# REVISED STAFF REPORT

## Staff Report OSLO BAY APARTMENTS SITE PLAN REVIEW and BOUNDARY LINE ADJUSTMENT

**To:** Heather Wright, Poulsbo Planning and Economic Development Director  
**From:** Karla Boughton, Special Projects Planner  
**Date:** Revised June 26, 2023 (originally issued August 12, 2022)  
**Subject:** Oslo Bay Apartments | Site Plan Review | P-12-05-19-01

**Figure 1: BLA Before and After Configurations**

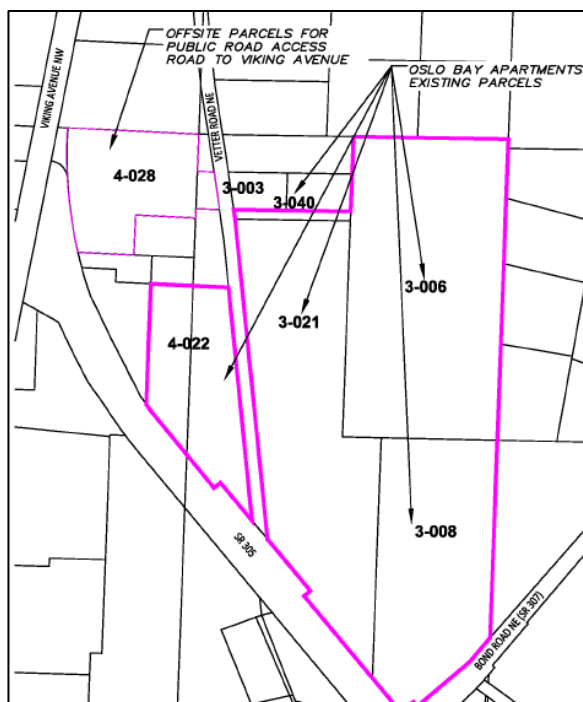
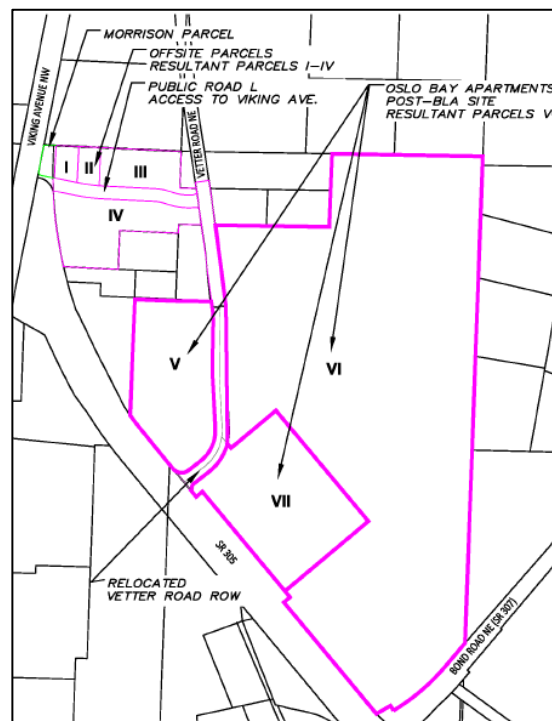
In Figure 1 below, Parcels after BLA, parcels I-IV are identified as off-site area and parcels V-VII are identified as on-site. The site and off-site parcels are noncontiguous but connected by Vetter Road ROW. Proposed improvements to the off-site parcels include only the construction of the new road L connecting Vetter Road NE to Viking Avenue NW. Improvements to the on-site parcels include the proposed apartment buildings and associated roads, utilities, parking, landscaping, and recreation amenities.

**Figure 9: Site Plan with highlights of on-site vehicle circulation and parking bays examples**

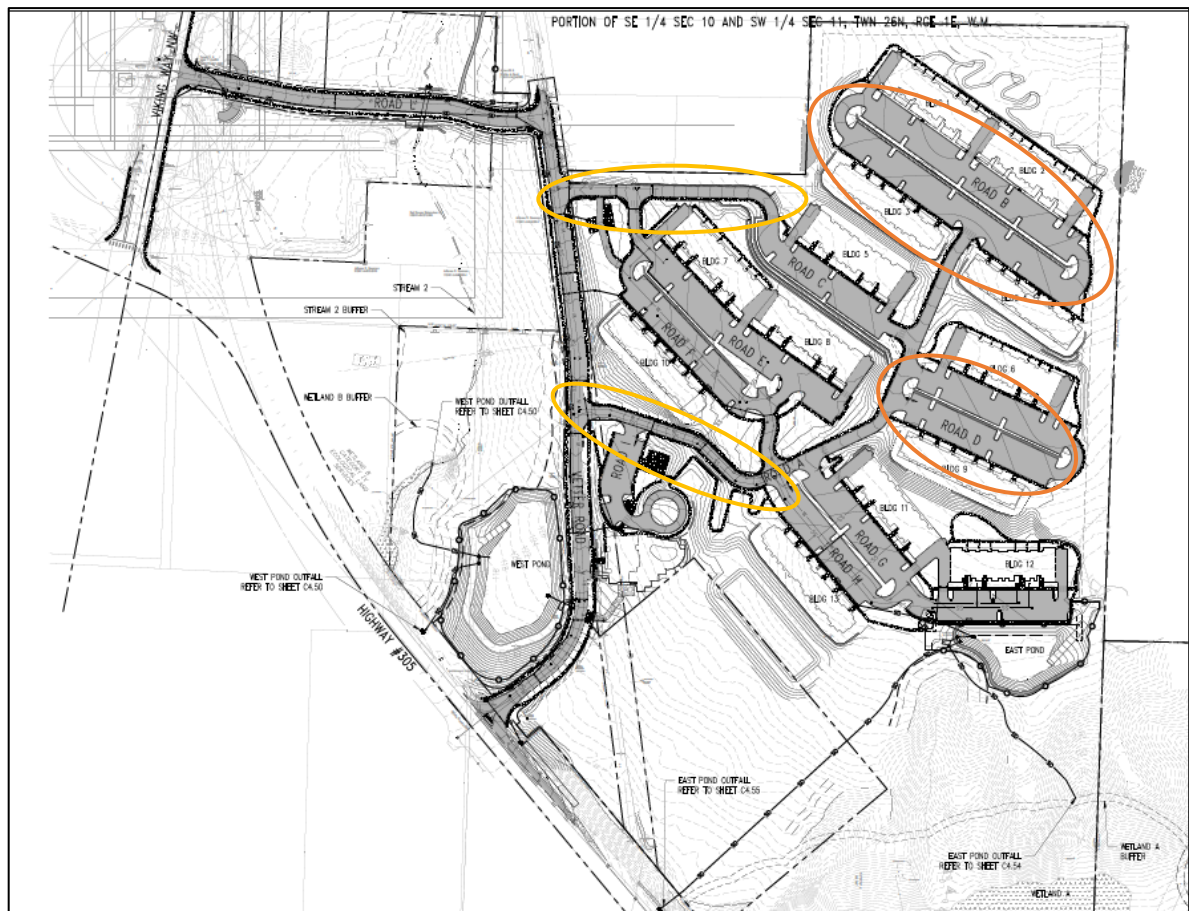
*Staff Comment:* On-site circulation is through several private streets that loop the development and circulate through a series of parking bays. The private streets must meet fire access road requirements. The private streets “Road A” and “Road C” connect to Vetter Road. The parking garages are not visible from the traveled way through the parking bays. The parking area for the Community Center is located 15' from Vetter Road NE and is screened by a landscaped buffer.

**Figure 12 Before and After BLAs Configurations****Existing Parcels****Proposed Resultant Parcels with BLAs****B. PMC 17.30.040 Decision Criteria**

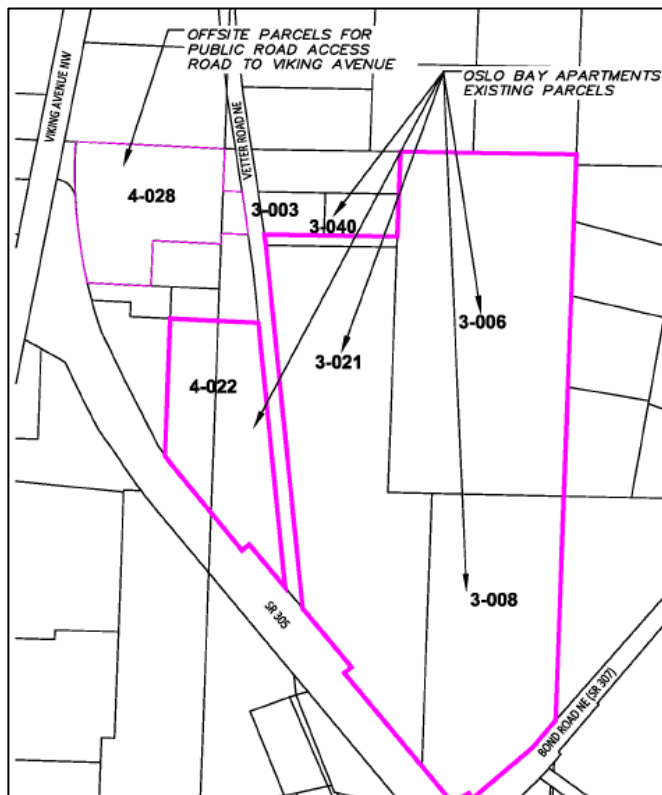
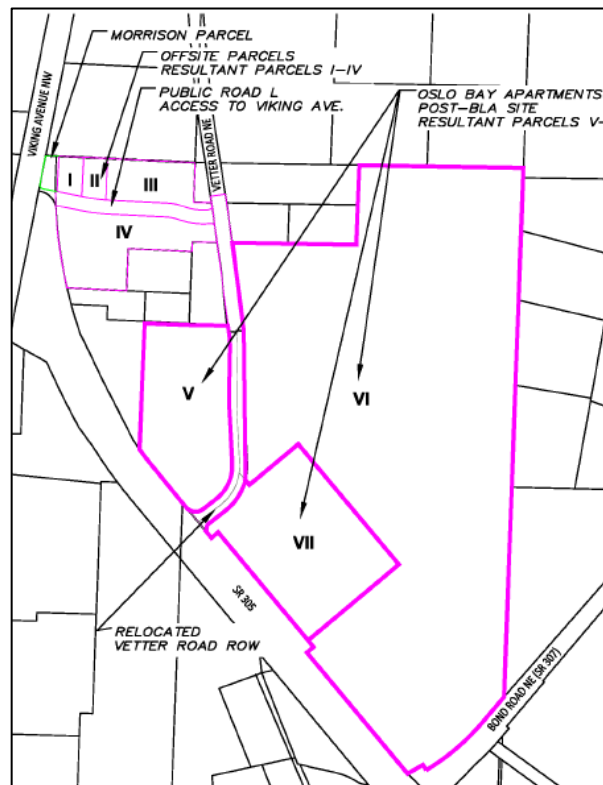
*Staff Comment:* The Oslo Bay Apartments project includes boundary line adjustments between lots owned by Edward Rose (project site), and a boundary line adjustment between Resultant Lot I and the adjacent “Morrison” property.

All BLA documents were peer reviewed by City’s consultant KPG land surveyors.

**Figure 13: Before and After BLAs Zoning**

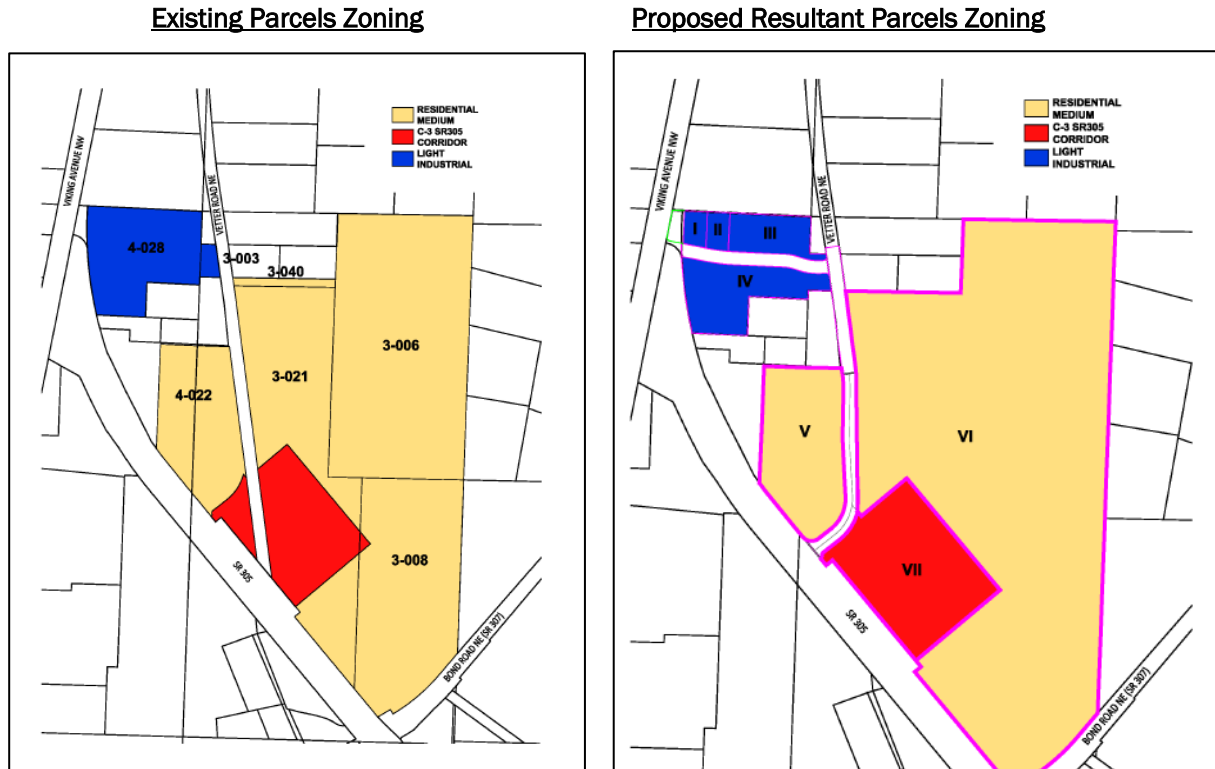
*Staff Comment:* The boundary line adjustments between the off-site parcels (I-IV) and between Parcel I and Morrison, are all zoned Light Industrial, and therefore no parcel will result in being located partially within and partially outside of any zoning.

On-site parcels V and VI are zoned Medium Density and Parcel VII is zoned commercial. The vacation and realignment of Vetter Road will modify and straighten Parcel VII's boundary but will not result in any parcel having more than one land use designation or zoning.

Figure 14: Project Site with Wetland and Streams

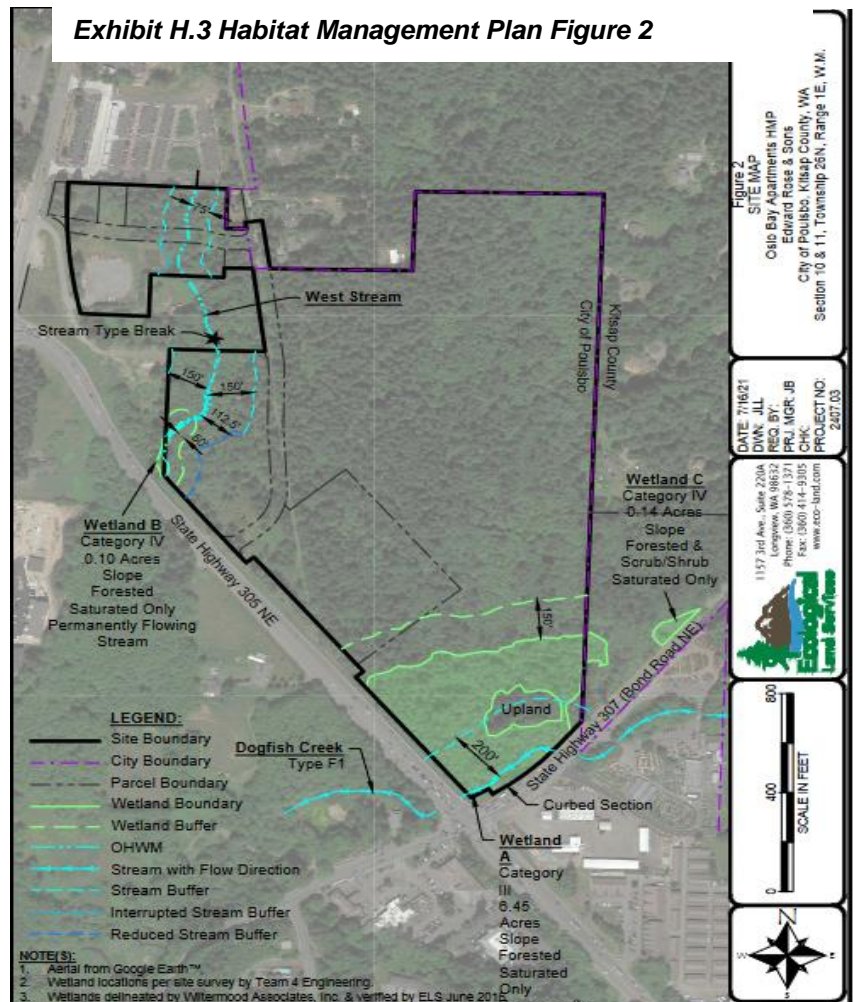
**Wetland A** lies on slopes above Dogfish Creek in the southeastern portion of the site. It is composed of a forested mosaic system community that has a sparse to moderately dense shrub and herbaceous layer. It is a sloping system fed by seepage that provides a source of hydrology to Dogfish Creek. Water drains down into Dogfish Creek via small rivulets that extend down the slope. A large upland area is situated near the bottom of the sloping wetland. This wetland meets the criteria for a Category III sloping system and is subject to a 150-foot buffer and 15-foot buffer setback per Poulsbo Municipal Code 16.20. The wetland buffer is the regulated buffer for this system as it extends beyond the Dogfish Creek buffer. **Wetland B** is a forested slope wetland located alongside the Western Stream that lies within the northwest portion of the project site. The associated stream flows southerly via a defined channel with narrow bands of riverine wetland along both sides. The onsite wetland terminates at the culvert under SR305, which constitutes the west boundary of the project site. **Wetland C** is a sloping wetland composed of forested and scrub/shrub vegetation communities. **Wetland C** is categorized as a Category IV sloping system and is subject to a 50-foot buffer and 15-foot buffer setback.

*Staff Comment:* There are no direct impacts to Wetlands A, B and C due to the Oslo Bay Apartments project. A small portion of stormwater discharge is proposed to be directed to edge of Wetland A's buffer and to the OHWM of the Western Stream, which is within Wetland B's buffer to retain wetland hydrology. These have evaluated by applicant submitted documents, and the SEPA memo addressed and provided appropriate mitigations.

**Figure 16: Road L Stream Crossing**

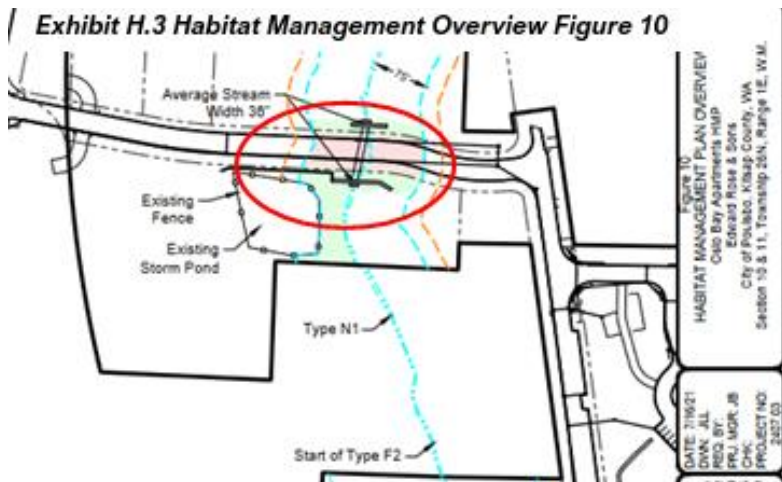
**Road L Stream Crossing and Buffer Impacts:** Road L will require a perpendicular crossing of the Western Stream Type Ns1 stream section with an 84" diameter, 94' long culvert. (See Figure 16 below.) The culvert has been sized to accommodate flows that exit the culvert emerging at the north line from the Kitsap Transit Center. The culvert will span at a narrow segment of the stream channel. Wing walls will help direct water flow into the culvert and avoid stream flows bypassing the culvert. The proposed culvert will be placed at a grade of 3.4 percent, which closely represents the current grade of the stream. Streambed gravels sized per WDFW specifications will be spread within the culvert. It is projected that approximately 55 cy of dredged material will be removed, and 55 cy of fill will be replaced as part of the Road L crossing. [Exhibit H.3 Habitat Management Plan](#) includes the "Stream Crossing Detail" as Figure 5 (pdf page 31).

*Staff Comment: The wingwalls proposed at the culvert ends will designed and constructed outside of the floodway and OHWM of the stream.*

**Figure 18: West Basin Stormwater Pond Stream Buffer Impacts**

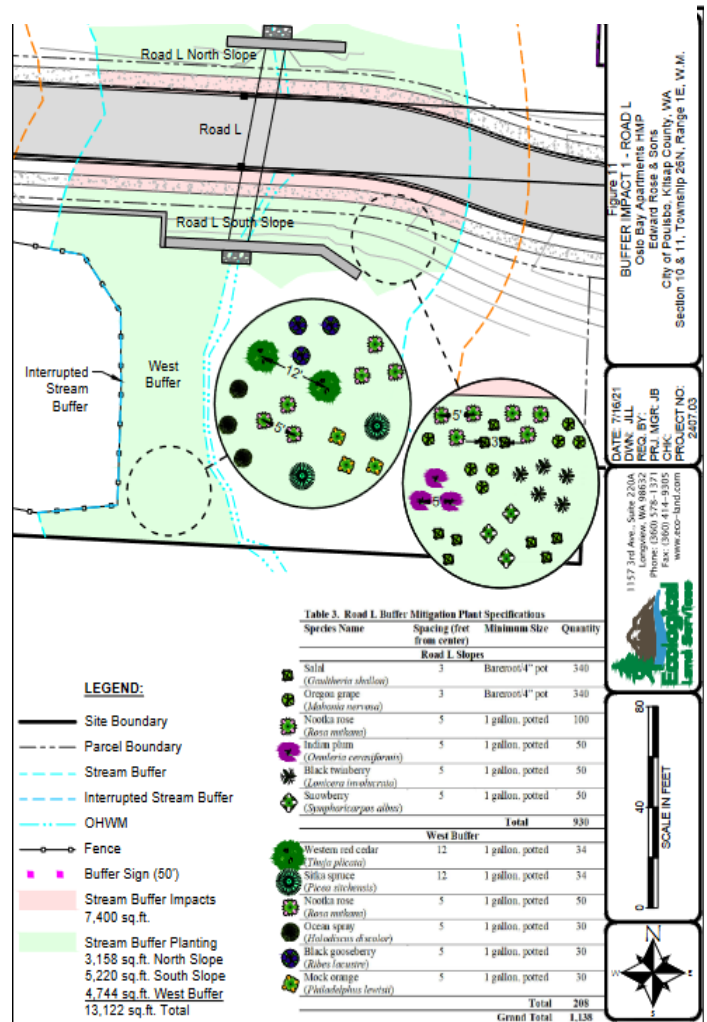
The West Basin Stormwater Pond is located to facilitate stormwater conveyance from the western portion of the project, including Road L. The required size of the pond is constrained by the Vetter Road alignment and impacts the Western Stream 150' buffer and 25' buffer setback. The applicant proposes to utilize the buffer reduction provision found in PMC 16.20.315.B.1 which allows reduction of up to 25% of the buffer width with submittal of a habitat management plan, which would result in a final buffer width of 112.5'.

In addition, the West Basin Stormwater Pond extends for approximately 2,886 square feet into the 25' buffer setback (from the 112.5' reduced buffer). The stormwater pond's fence will be along the edge of the setback. Minor encroachments into the buffer setback are allowed per PMC 16.20.315.A(5)(b) upon submittal of a habitat management plan. See Figure 18 - Exhibit H.3 Habitat Management Plan Figure 12 below. Red highlighted along western edged of stormwater pond is stream buffer impacts (7,533 square feet), red hatched area is steam setback impacts from reduced 112.5' buffer width (2,886 square feet), and green highlight is proposed stream buffer mitigation of 6,154 square feet.

The stream buffer reduction is proposed in an area that has the lowest current cover of native vegetation. Wetland B is adjacent and associated with the Western Stream and will be maintained, which will also contribute to the function of the stream buffer.

*Staff Comment:* There are no direct impacts to Dogfish Creek. There are two impacts proposed to the Western Stream: 1) Road L will make a stream crossing at the northern portion of the stream; and 2) stream buffer reduction is proposed for the area adjacent to the West Basin Stormwater Pond to 112.5' and minor encroachment into the 25' buffer setback area. A Habitat Management Plan (Exhibit H.3) has been prepared to justify and mitigate these impacts to the Western Stream buffer.

Figure 20: FEMA Flood Insurance Rate Map depicting Flood Hazard Area

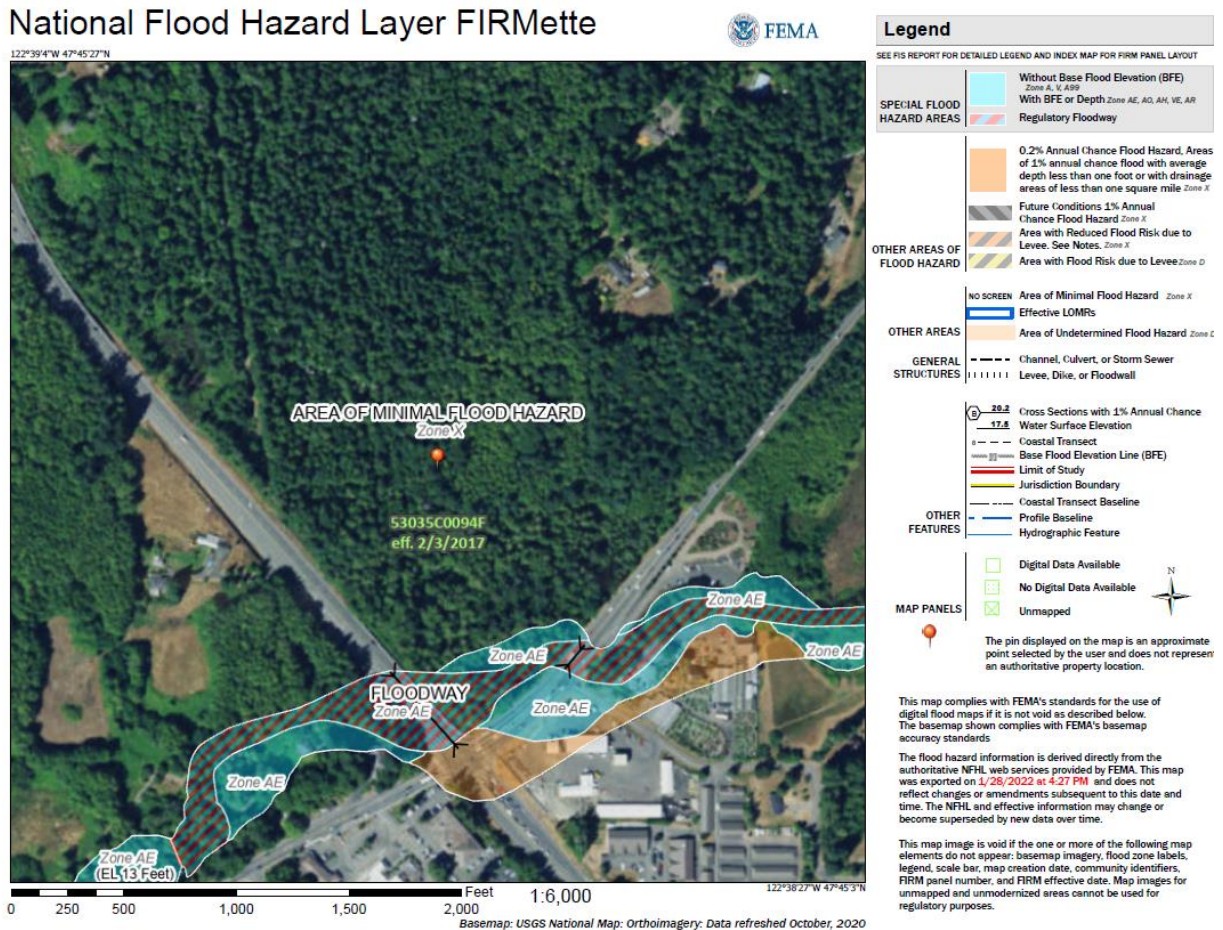
Staff Comment: No impacts are identified to the 100-year Floodplain zone as site development is over 600' from the flood zone and Dogfish Creek.
